6th August 2020

Reference: 200537.01FA

LETTER OF RESPONSE TO TfNSW FOR SUTHERLAND ENTERTAINMENT CENTRE AT 30 ETON STREET, SUTHERLAND

(Sheet 1 of 2)

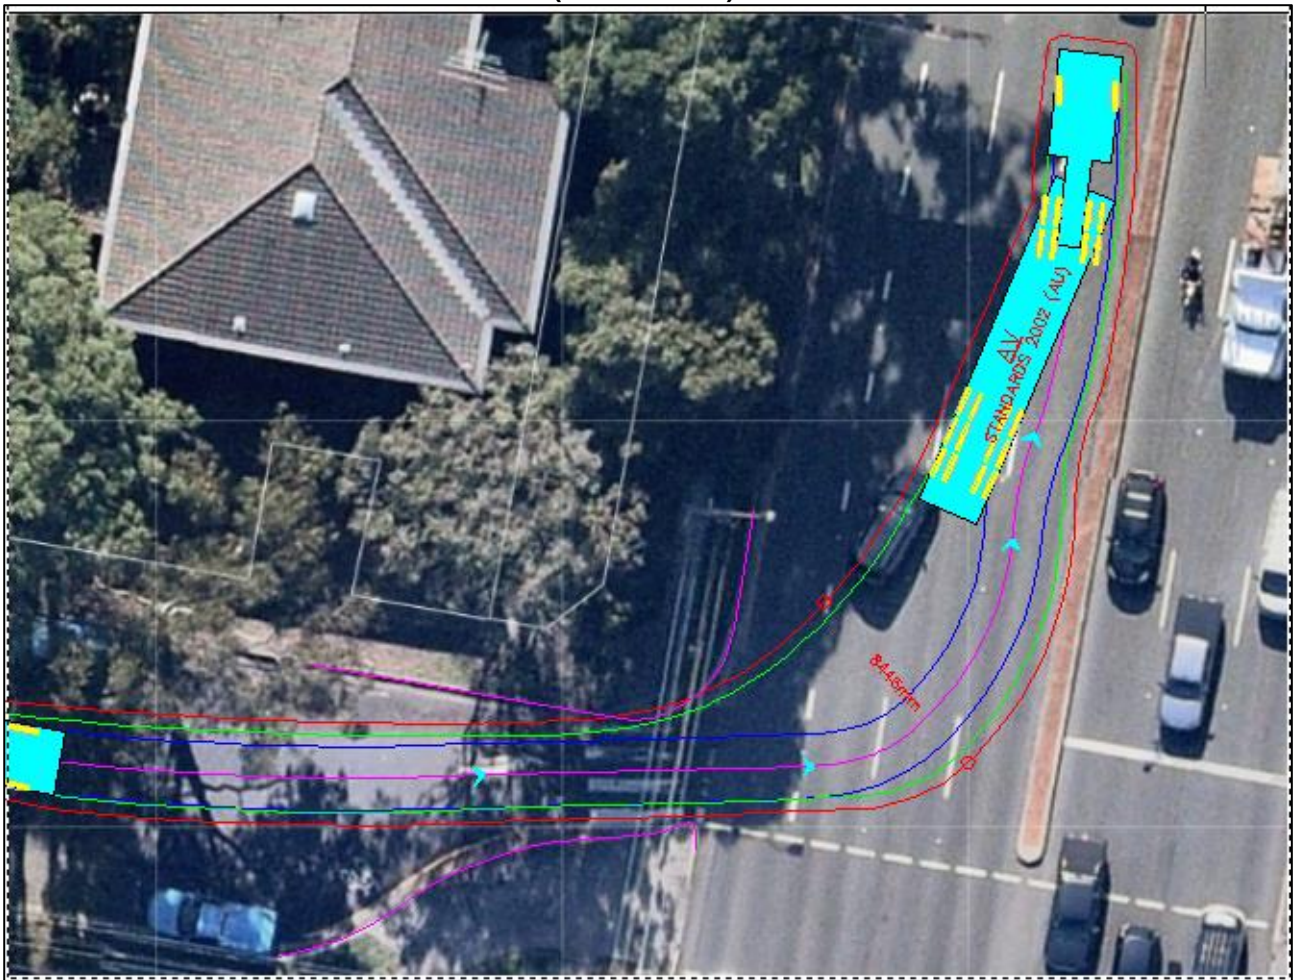
It is requested that the applicant be conditioned to submit swept path design plans of the longest vehicle (including garbage trucks, building maintenance vehicles and removalists) entering and exiting the subject site, as well as manoeuvrability through the site, to Council for approval, prior to issue of the first Construction Certificate

The layout of the proposed car parking areas associated with the subject development (including driveways, grades, turn paths, sight distance requirements in relation to landscaping and / or fencing, aisle widths, aisle lengths, and parking bay dimensions) shall be in accordance with AS2890.1:2004, AS2890.6:2009 and AS2890.2:2018 heavy vehicle usage

Swept path testing for a 19m length Articulated Vehicle has been undertaken at the intersection of Acacia Road and President Avenue and Flora Street onto Acacia Road and is reproduced in **Annexure B** for reference. These paths demonstrate that the vehicles do not travel onto the kerb and medians.

19m length left turn onto Acacia Road from Flora Street

Tested @ 5km/h

Successful – vehicle does not travel over the kerb
